## ARCHITECT'S ADDENDUM

Addendum Number: 002

**RE:** Judicial Center Campus Parking  
Lot Improvements

Subject: Addendum No. 02 to the Construction Documents and Project Manual for the Judicial Center Campus Parking Lot Improvements project.

PROJECT NORTH  
BASE BID PHASE II  
NOT TO SCALE

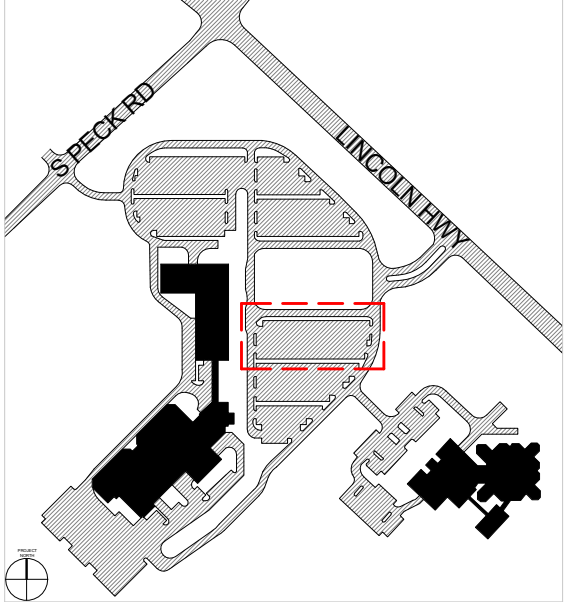
6. *There are sectional curb repairs (approximately 100 linear feet) called out on plan sheet A2.2 – Base Bid Phase II. The same sectional curb repairs are also called out on plan sheet A2.4 – Alternate 1. Please clarify if the 100' of sectional curb repairs is to be included in the Base Bid or Alternate 1.*

Response: The sectional curb repairs are part of Base Bid- Phase III. See revised sheets A2.2 and A2.4 issued as Addendum 2 dated 11.30.2017.

SECTIONAL CURB REPAIRS

ALT ERNATE - 2  
NOT TO SCALE

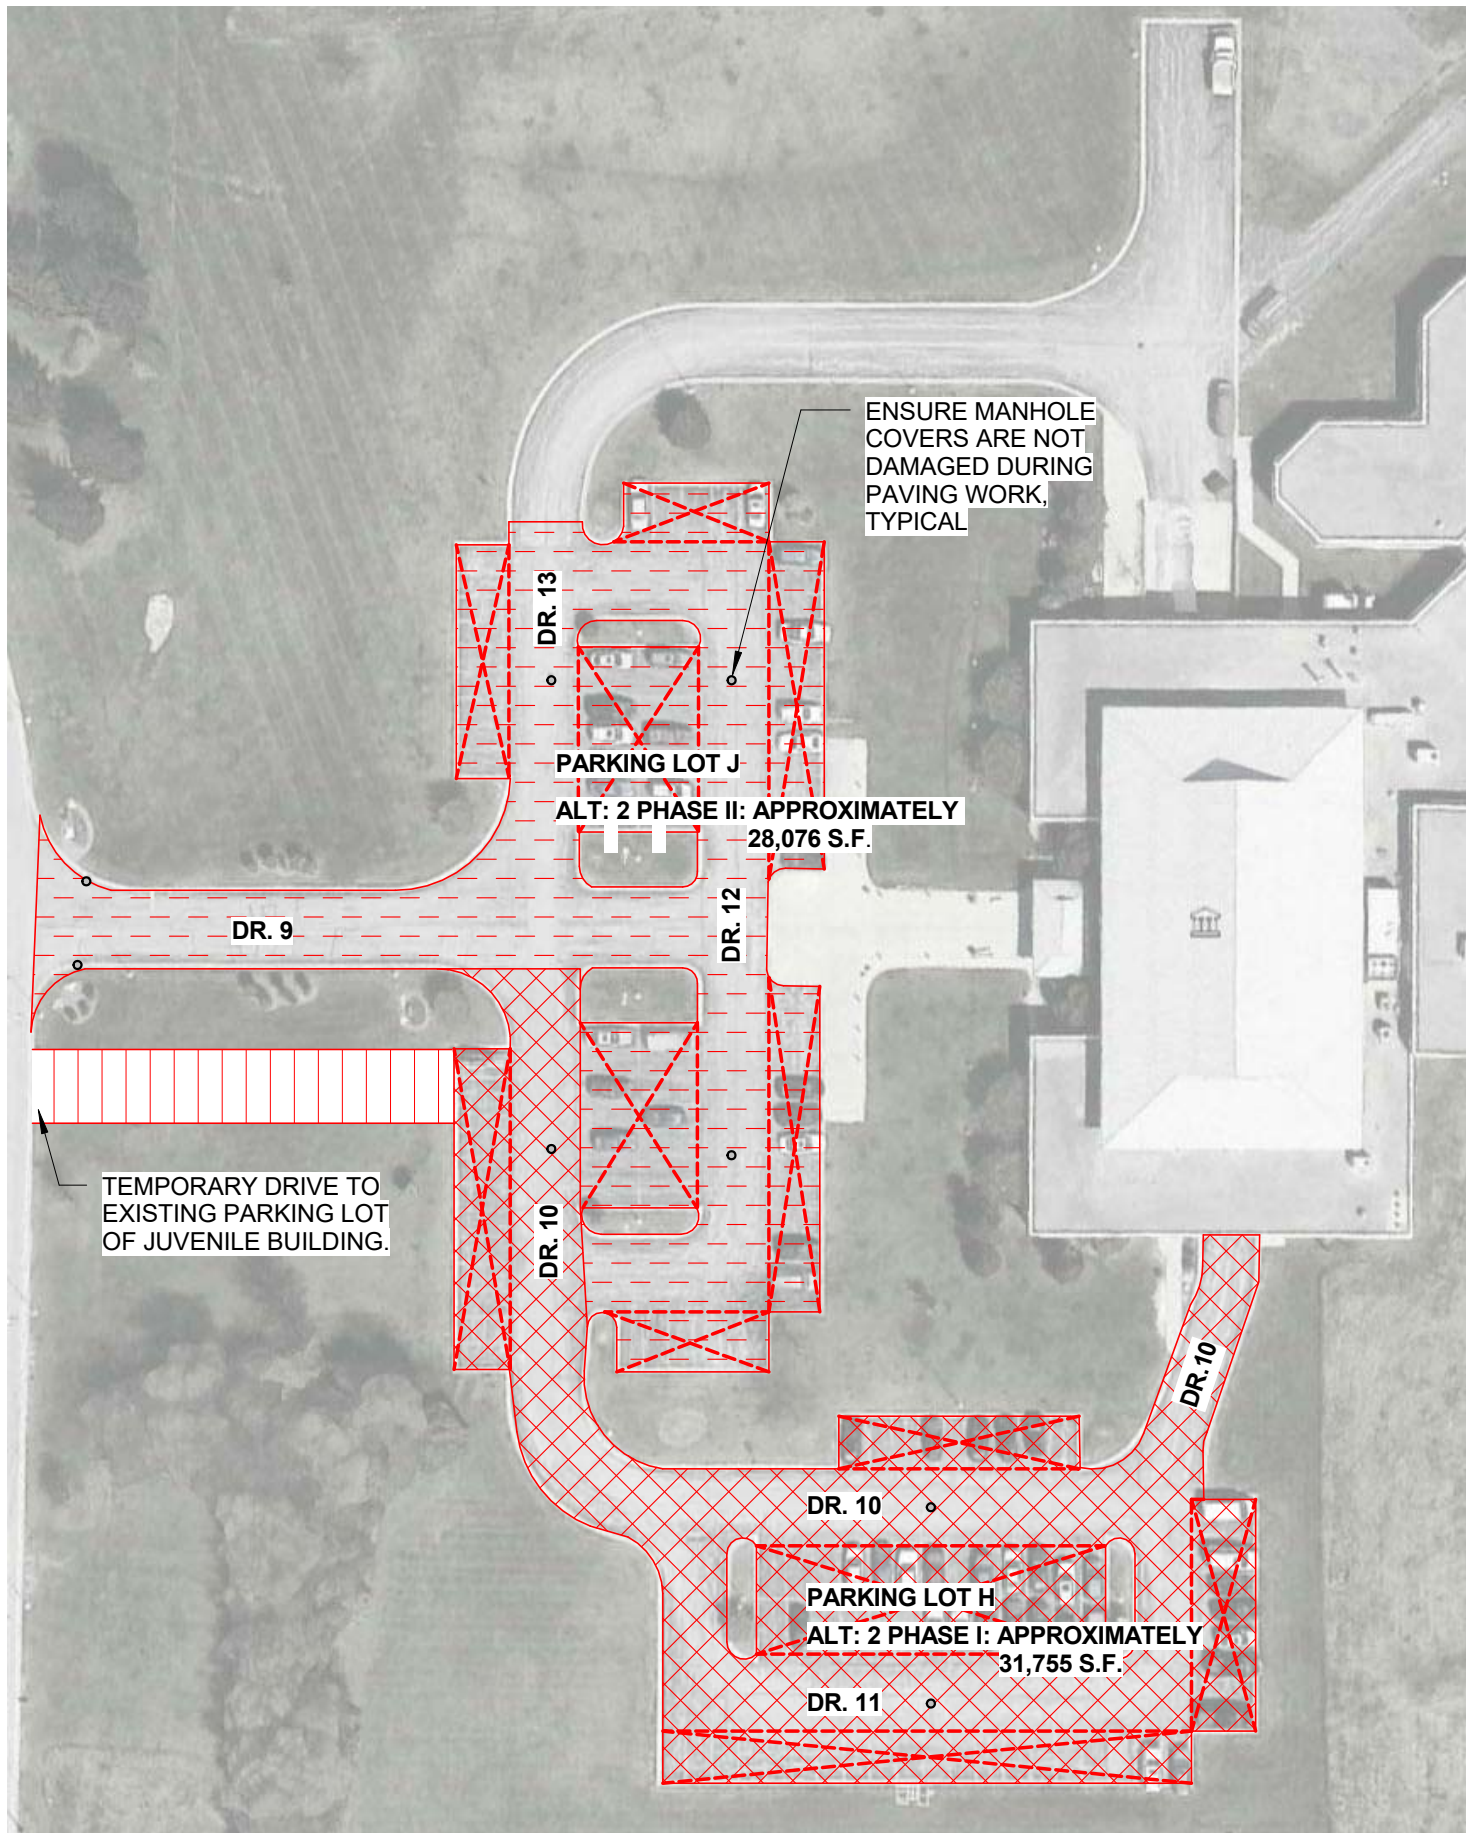
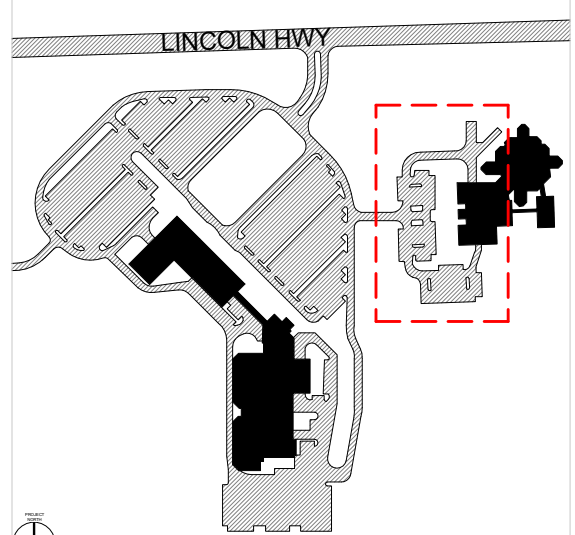
8. *Plan sheet A2.5 does not delineate limits for proposed standard duty and heavy duty pavement sections for Alternate 2. Are all driveways / drive aisles to be heavy duty pavement and all parking bays / parking areas to be standard duty pavement? Please clarify.*

11. *I have a question in regards to Sheet A2.5. The notes state to remove the existing pavement and 4" of subgrade soils to meet the proposed pavement designs. After reading the soils report, I assume we are to remove existing asphalt, existing aggregate base (credit for stockpiling and reuse) and existing subgrade to make room for a standard and heavy duty pavement section which are 11.75" and 16" respectively. Am I correct in this assumption?*

12. *Secondly, am I to assume the parking stalls are standard duty and the drive aisles are heavy duty?*

15. *Alternate 2- Phase 1 and 2 - Sheet A2.5 Note 3b. I assume this price should be a unit price because we will not know what area needs undercut until that time comes. Please confirm.*

16. *Sheet A2.5 Note 4a and 4b. What area is to receive standard duty asphalt and what area is to receive heavy duty asphalt?*

Response: After removal of the temporary drive the area should be restored back to match the existing landscape condition. Refer to revised note on A2.5 issued as Addendum 2 dated 11.30.2017

Response: Refer to revised sheet A2.5 issued as Addendum 2 dated 11.30.2017.

Response: The assumption is correct.

Response: Parking stalls are standard duty and drive aisles are heavy duty. Refer to revised sheet A2.5 issued as Addendum 2 dated 11.30.2017.

Response: It is listed as unit price under "G - Unit Prices" in Bid form page 5 (004000-5) as item #8.

Response: Parking stalls are standard duty and drive aisles are heavy duty. Refer to

revised sheet A2.5 issued as Addendum 2 dated 11.30.2017.

- SURFACE COAT METHODS:
  - PARKING AREA (STANDARD DUTY REPRESENTED BY 'X' IN THE DRAWING)
    - 1 1/2" ASPHALT CONCRETE SURFACE COURSE OVER 2 1/4" ASPHALTIC CONCRETE BINDER COURSE

- DRIVE AISLE (HEAVY DUTY)
    - 2" ASPHALT CONCRETE SURFACE COURSE OVER 4" ASPHALTIC CONCRETE BINDER COURSE
- STRIPING: AFTER COMPLETION OF NEW PAVEMENT, COMPLETE THE PARKING LOTS WITH STRIPING TO MATCH TO EXISTING PARKING LAYOUT.
